Arizona Nuclear Power Project

Subject: Palo Verde Nuclear Generating Station
Unit 1
Docket No. STN 50-528 (License No. NPF-41)
Natural Circulation Testing at PVNGS Unit 1
File: 86-056-026

DISCUSSION OF TEST PROCEDURE DIFFERENCES

Figure 1 - Natural Circulation Test Data

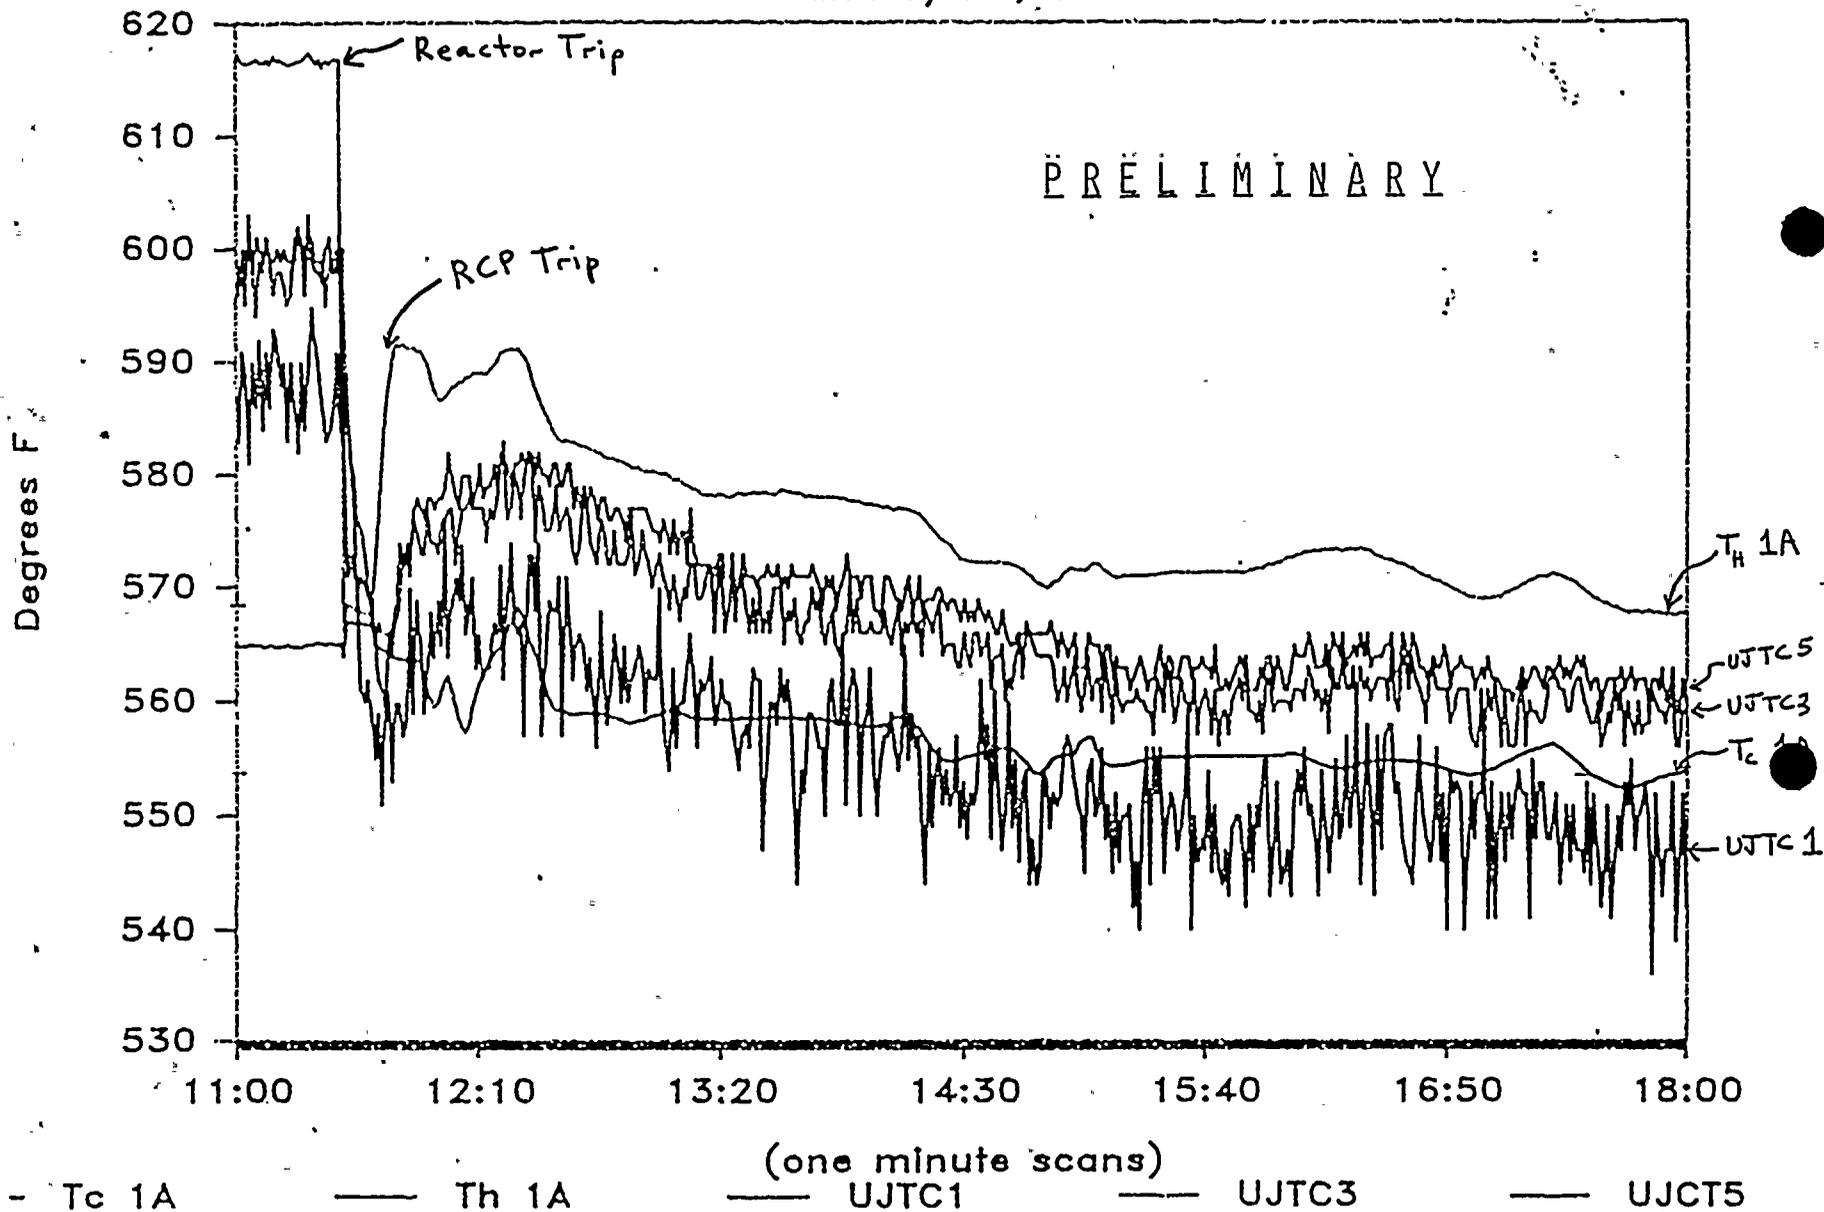
Preliminary review of the Palo Verde natural circulation test data supports this conclusion. Figure 1 shows that the temperatures in the upper head stabilize soon after the hot leg temperature stabilized. This indicates initiation of a steady state condition in the upper head as was predicted based on the San Onofre natural circulation test results. Figure 2 shows the approximate locations of the RVUH thermocouples at Palo Verde.

FIGURE 3

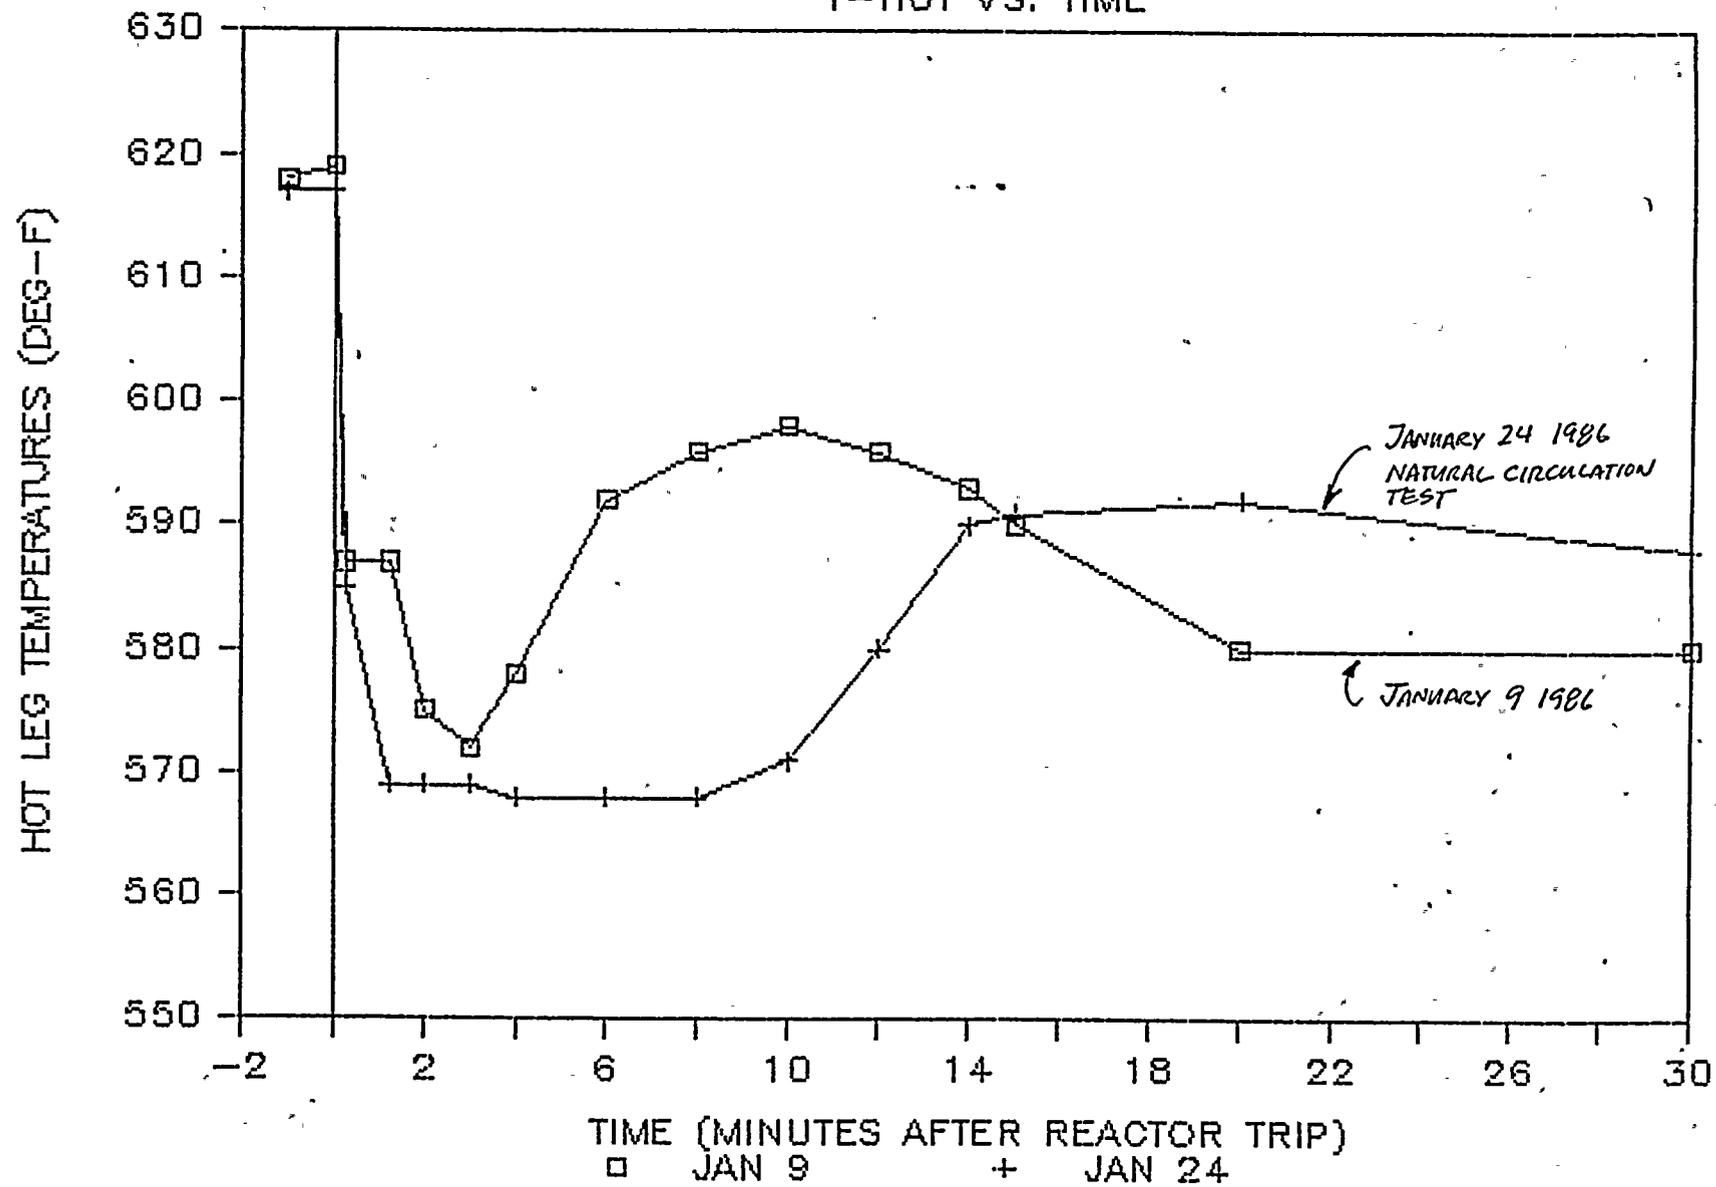
At the request of the NRC Staff, the following additional data has been provided. Figure 3 shows the Palo Verde hot leg temperatures for the January 9, 1986 turbine trip test and the January 24, 1986 natural circulation test. In the January 9 test, failure of the fast-transfer of non-essential station loads to the offsite power resulted in loss of power to the RCPs. This data was requested to show the system response to a reactor trip initiated by a loss of flow event. This data shows that the hot leg temperature remains below the full power temperature at all times following the reactor trip. It should be noted that hot leg temperatures during the January 9, 1986 event reflect a slight overcooling of the reactor coolant system initially following the trip. When the hot leg temperatures are corrected for the overcooling, the actual plant response is still bounded by the existing safety analyses.

RCS HEAD VENTS

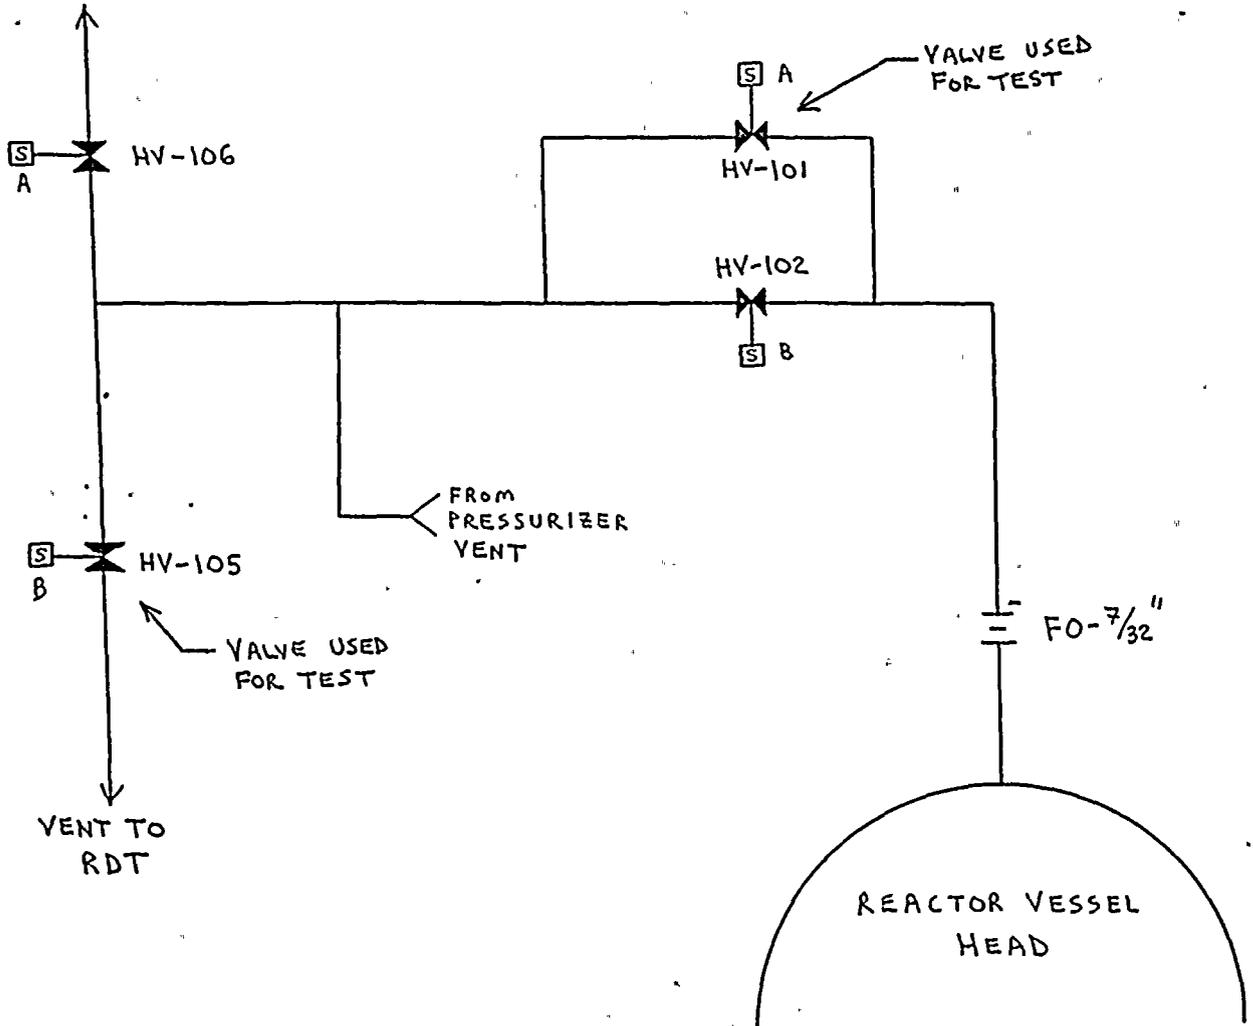
Reference (2) submitted certain test procedure changes to the NRC Staff for review. One of these changes was a commitment to change the test procedure to assume the most limiting single failure (i.e., the failure of one diesel generator). The test procedure was modified to assume the failure of the A-train diesel generator. Thus, only B-train safety related equipment was to be relied upon during the test. Therefore, the use of the A-train vent valve (RCA-HV-101) during the test was not in accordance with the commitment made to the NRC Staff.

This change, to make use of the A-train vent valve, was made to satisfy a separate licensing commitment which is documented in the response to question 5A.22 of the PVNGS FSAR. This FSAR commitment was made for safety purposes and it states, "to minimize the possibility of a common mode failure of solenoid operated valves to shut when de-energized, the operation procedure for the RCS gas vent system will require that when both Trains A and B are available that one valve powered from Train A and one valve powered from Train B will be used to complete a vent path."

For the purposes of this natural circulation test and to ensure plant safety, the FSAR commitment was complied with and one A-train valve and one B-train valve was used. Had this been an actual loss of forced circulation event under the assumptions of BTP RSB 5-1, the reactor vessel head vent path could have been completed using only B-train components (refer to the attached system diagram). This would not have resulted in any differences in system performance characteristics from those observed during the natural circulation test.
